Ahmend Fashions

34/1, Darussalam Road, Dhaka
(23.783165 N, 90.351141 E)

Survey Date: 4th March 2015

Observations

Heavy Loading on Roofs over east and west stairs

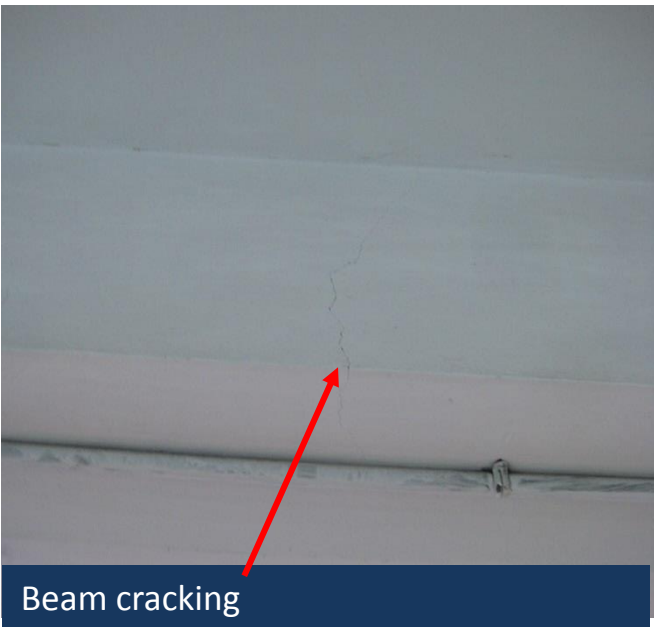
Sand on roof over east stair

Water tanks on roof over west stair

Heavy Loading on roof

- There is a layer of sand approx. 400mm thick over the west stair.
- There are 6 no. 1000 litre water tanks on the roof over the east stair.
- Building engineer to check structure for load from water tanks and sand, and remove if required.

Item No.	Observation	Recommended Action Plan	Recommended Timeline
10	Heavy Loading on Roofs over east and west stairs	As part of the Detail Engineering Assessment (see Item 1), Building Engineer to check the capacity of the structure to carry the load from the water tanks and the sand.	6-weeks
11	Heavy Loading on Roofs over east and west stairs	Remove water tanks and/or sand from roof, as required.	6-weeks
12	Heavy Loading on Roofs over east and west stairs	Carry out any remedial structural works as required after assessment.	6-months
13	Beam and slab cracking at all floors	Sections of plaster finish to beams and slab to be removed to investigate if cracks penetrate the building structure.	6-weeks
14	Beam and slab cracking at all floors	As part of the Detail Engineering Assessment (see Item 1), Building Engineer to carry out design check on beams and slab taking into account the effect of the cracks on the structure	6-weeks

Beam cracking

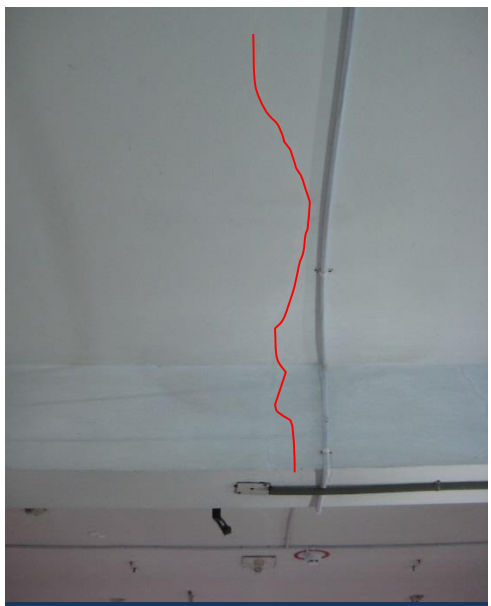
Crack continues up side of beam and into slab

Beam and slab cracking

- Cracking to underside of beam noted on all floors.
- Some cracks continue up the side of the beam and into the slab.
- Some cracks have been filled and painted.
- Building Engineer to investigate cracks and determine if they are structurally significant.

Beam cracking

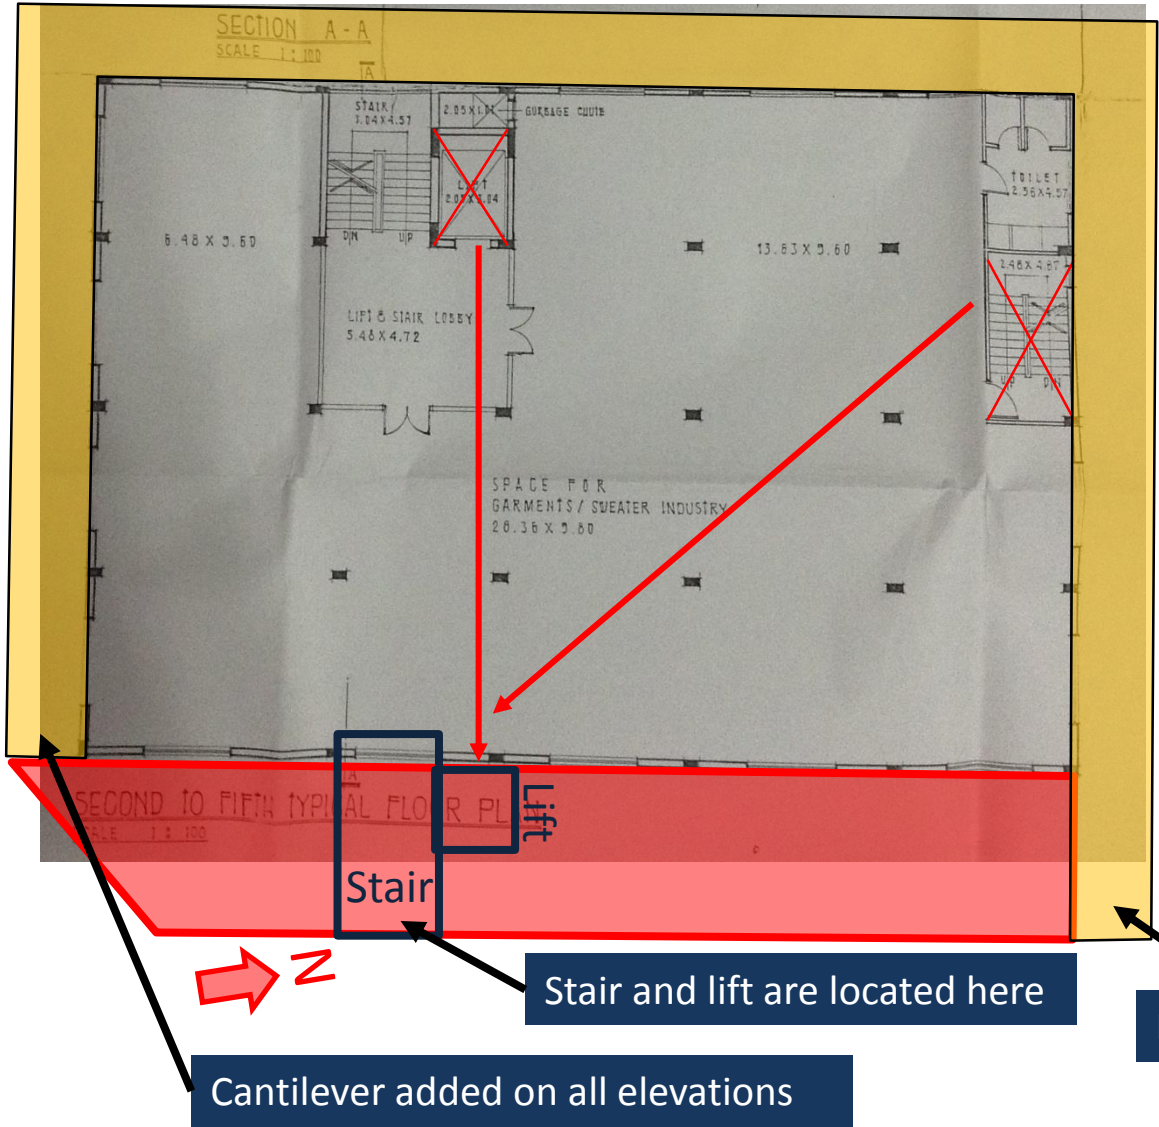
Cracks have been filled and painted
